Attachment D

Replacement SCA Pages and Figures

Levy Nuclear Plant Units 1 and 2

Site Certification Application Revision Tracking Sheet

Progress Energy Florida Levy Nuclear Plant Units 1 and 2 Site Certification Application
Governmental Jurisdictions 1 Mile Radius FIGURE 3.2.1-2 Rev 3

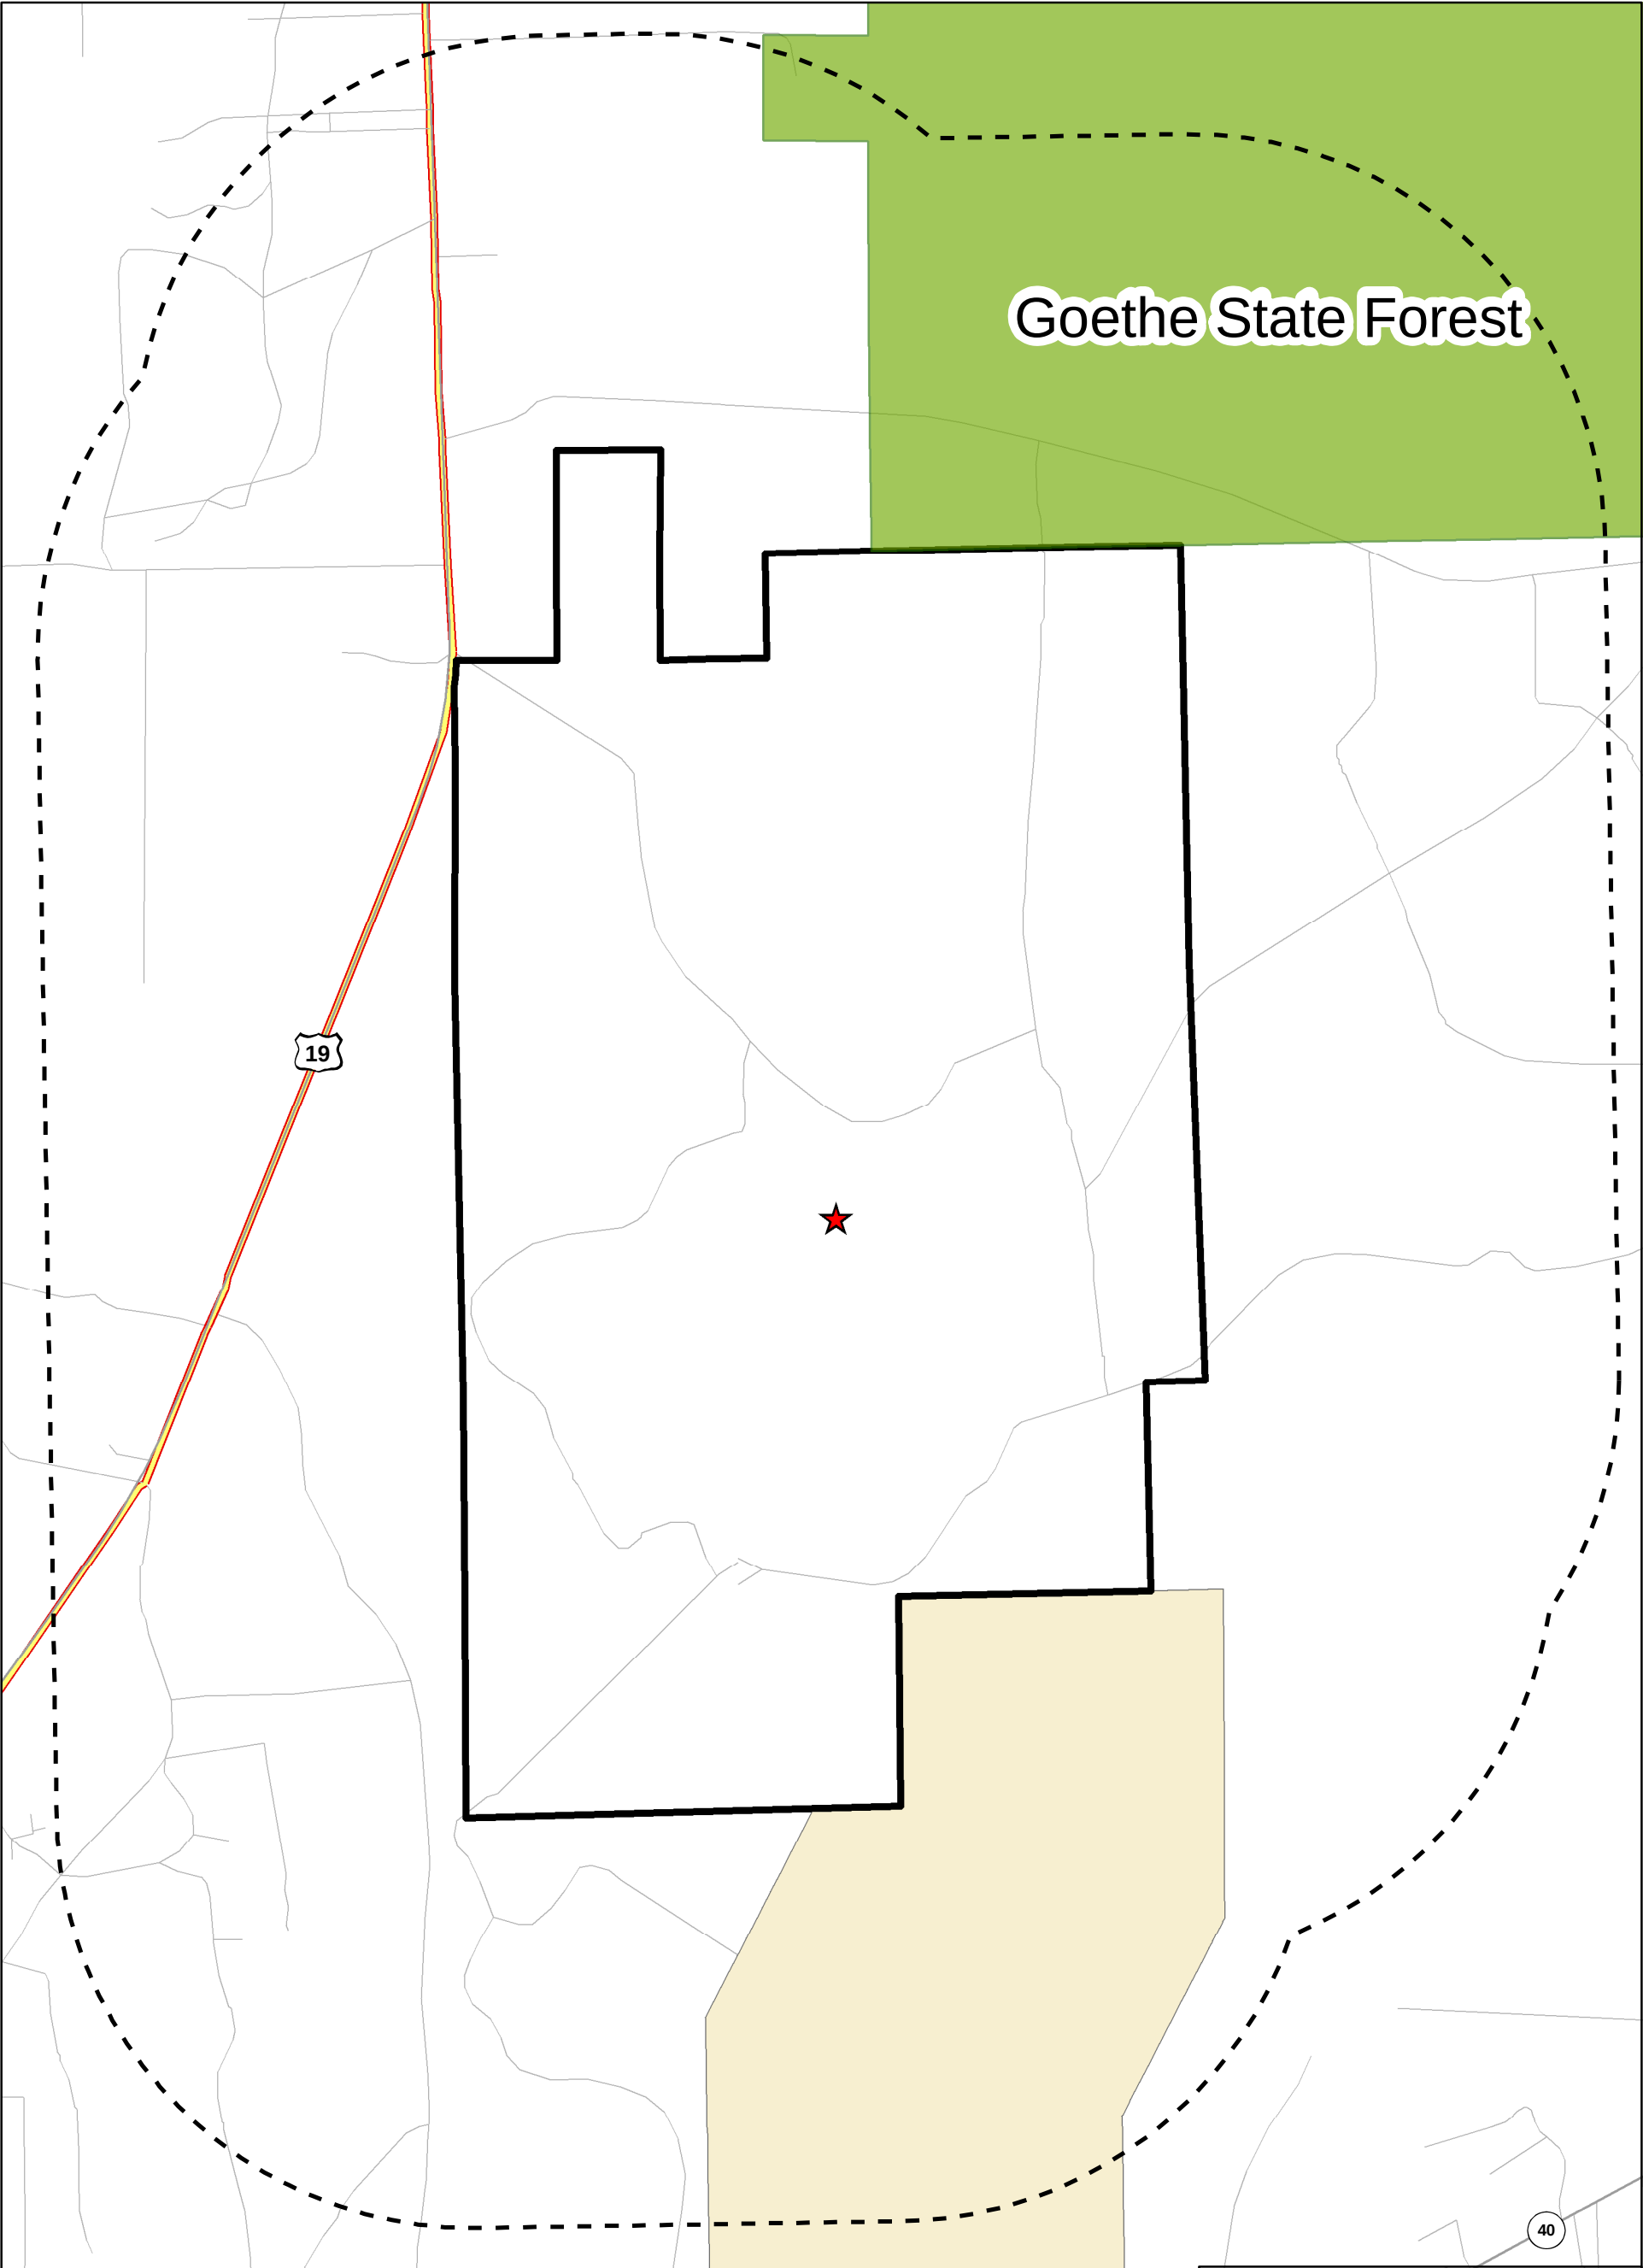
Date	Pages Affected	Reason For Change
April 29, 2010	As noted in the following table. (Table includes Rev. 3 changes) Pages changed to "Rev. 3"	Pursuant to PEF's Petition for Modification of the Site Certification Order submitted April 29, 2010 to the Florida Department of Environmental Protection (FDEP), PEF is revising the Site Certification Application (SCA) to address the modifications to the corridor for the pipelines and heavy haul road.
